# TRANSMITTAL LETTER FOR SERVICE BULLETIN NMD-35-02 Rev 2

# OXYGEN - CABIN SUPPLY PIPE - ADDITION OF PROTECTIVE SLEEVE (Mod N689)

Figure 1 Installation of Protective Sleeve

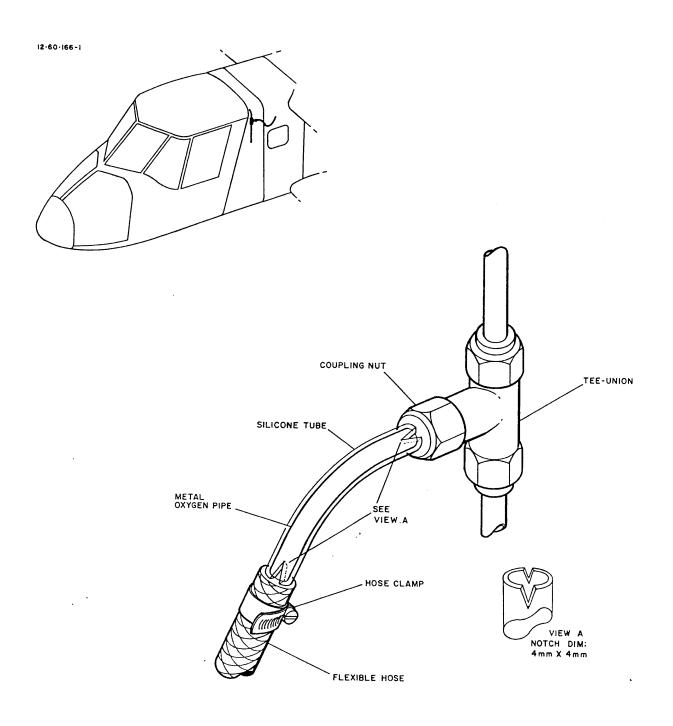
- E. On Oxygen pipe PN 1A/N-71-117 (Ref IPC, Option G71B, Fig 1, page 2, item 37 and similarly for Options G71C and R72), measure the length of metal pipe from the end of the flexible hose to the rear face of the coupling nut at the tee-union, and cut a piece of clear silicone tube, 3/8 inch inside diameter, to this length. Notch the ends of the silicone tubing as shown at Figure 1.

- Clean the pipe with a suitable oxygen degreasing agent, such as MEK or acetone, and slide the silicone tubing over the beaded end, and along the pipe until it touches against the rear face of the coupling nut.

The oxygen pipe behind the panel is protected by installing an insulating sleeve over it (Ref Fig 1).

- L. When satisfactory adjustment has been made, tighten the coupling nut onto the tee-union, and tighten the hose clamp on the flexible hose. Ensure that the silicone tube is held between the rear face of the coupling nut and the end of the flexible hose, without looseness, or movement along the pipe.
